DEPARTMENT OF ENVIRONMENTAL CONSERVATION

FIELD INSPECTION REPORT NIBLACK MINING COMPANY

Inspection Date: May 7, 2008
Report Date: May 19, 2008
Weather: Mild, partly sunny with no rain
Inspection Objectives: To conduct a routine inspection of the general project area and compliance with the ADEC Waste Management Permit.
Operator Contact: Darwin Green, VP Niblack Mining Company, Geologist
State Personnel: Ed Emswiler, ADEC; Kenwyn George, ADEC
Steve McGroarty, ADNR
Other Personnel: Greg Killinger, USFS – District Ranger
Dennis Benson, USFS, Recreational Lands, Minerals & Heritage
Jeff DeFreest, USFS, Tongass National Forest Mines Manager
Laura Hudson, Project Manager / geologist
Ken Danielson, Camp Manager
Barry Hogarty, water quality sampling
Redpath construction foreman
Documentation: Photos were taken and are available for inspection at ADEC in Juneau

PAG site underdrain

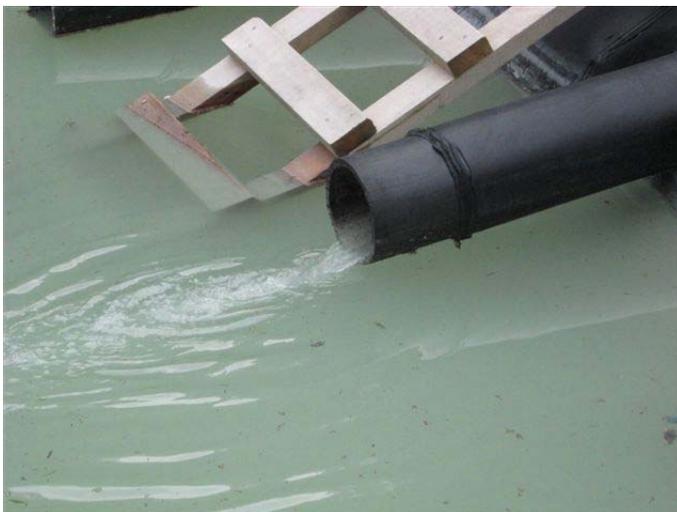
The leak detection culvert beneath the PAG site was observed. No water was detected leaving the culvert. The perforated PVC culvert was placed at the lower aspect of the facility and surrounded by rock prior to placement of the liner system mentioned above. Mr. Green reported that blasting of the rock pit in preparation of the foundation may have created small cracks or fissures in the foundation rock and that the leak detection system may not fully be able to collect all of the water passing a ruptured liner because of these cracks. This means that the leak detection system will not be 100% effective at detecting leaks in the liner system.

Because of this, Niblack is advised to ensure that operators work to maintain the integrity of the liner during disposal operations and diligently conduct visual inspections of the leak detection system. At closure attention will be given to ensuring that all of the stored PAG/ML waste will be picked up from the PAG facility and placed back into the exploration adit. **SEE ACTION ITEMS.**

Mine dewatering water entering the first water treatment pond.

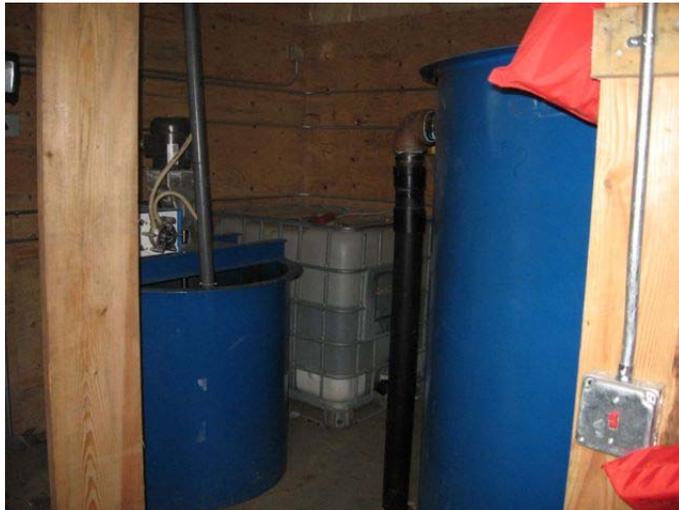
Sedimentation Ponds: The two sedimentation ponds for the mine dewatering water were full and operating. Water entering the first pond from the mine at a rate of ~ 40-45 gpm was extremely turbid and sediment laden. A gravity feed drip flocculent tank was located at the inlet to the ponds, however, the efficiency of the feed is poor because of variation of flow into the pond (mine sump pump is either operating or idle). Water was then allowed to flow into a second pond by gravity via surface outlet pipe work between the two ponds opposite the inlet to the first pond. Water from the “Potentially Acid Generating (PAG) Site” was allowed to drain by gravity into the second pond because the small flow and metals loading of the discharge from the PAG facility was low. The flexible pipe that delivered water at the ponds could be positioned at either pond. There was marked visual turbidity to the water of the first pond. The visual turbidity in the second pond was markedly less. It appeared as though the sedimentation process via gravity between the two ponds was somewhat effective. Water quality from the ponds, for the two samples taken in 2007 was seen to be low in metals and not adversely impacting the quality of ground water.
